<b>AMENDMENT OF SOLICITATION/MODIFICATION OF CONTRACT</b>			1. Contract Number	Page of Pages 1   1	
2. Amendment/Modification Number  <b>DCAM-2011-B-0182-003</b>		3. Effective Date  14-Sep-11	4. Requisition/Purchase Request No.	5. Solicitation Caption  <b>Renovation of the DC Animal Shelter</b>

1. Attachment J.1.2 - Drawings, delete: drawing number C-1-1 and drawing number E-1-1 therein and substitute: revised drawing number C-1-1 and revised drawing number E-1-1 attached herewith to Amendment No. DCAM-2011-B-0182-001.

**ATTACHMENT NO. 1 TO AMENDMENT #3  
TO SOLICITATION NO. DCAM-2011-B-0182**

NO. 1	DATE	DESCRIPTION	BY	APP.
1	1/20/56	EXISTING PARKING		
2	1/20/56	DC ANIMAL SHELTER		
3	1/20/56	1201 NEW YORK AVENUE NE.		
4	1/20/56	WASHINGTON DC 20002		
PROJECT NO.			DOHASI	
DRAWING NO.			C-1-1	
DATE			7-21-51

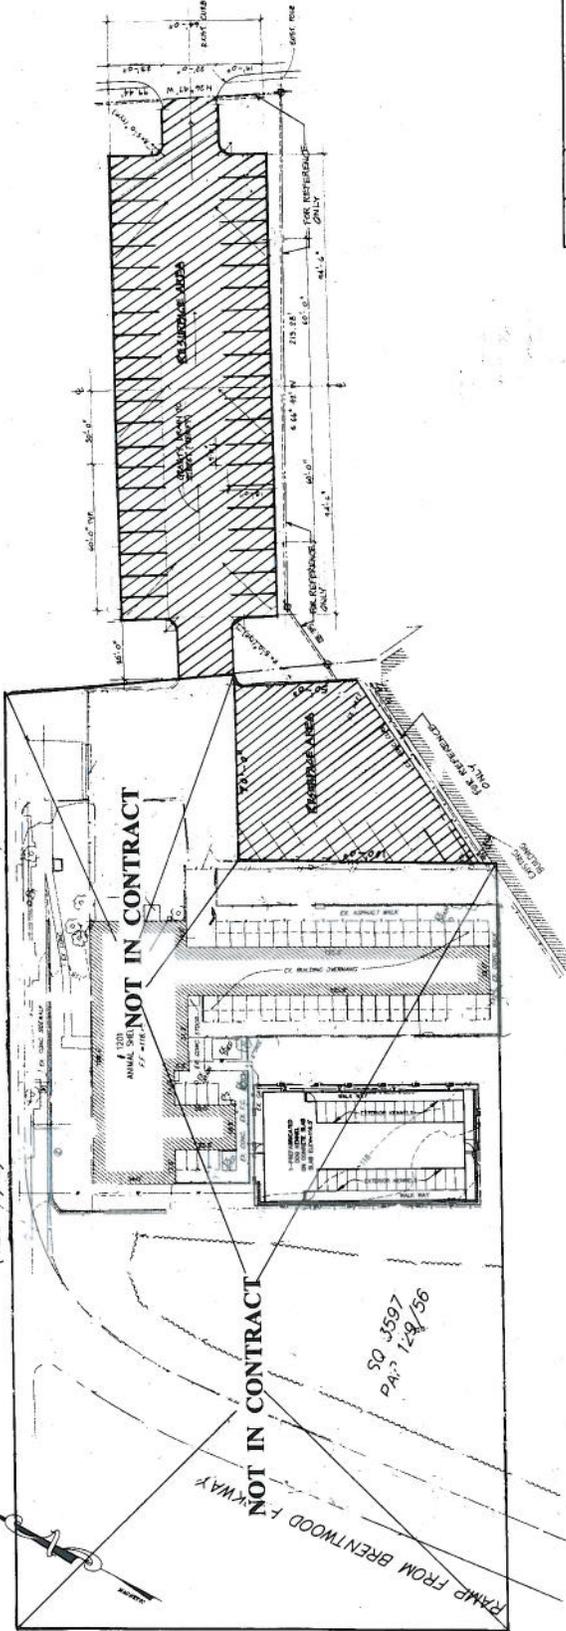
The civil drawing shows a 1.5' overlay on the parking lot away from the shelter ("19,000 SF). Is this parking lot to be milled or just paved?

There is no milling of the parking lot, only paving.
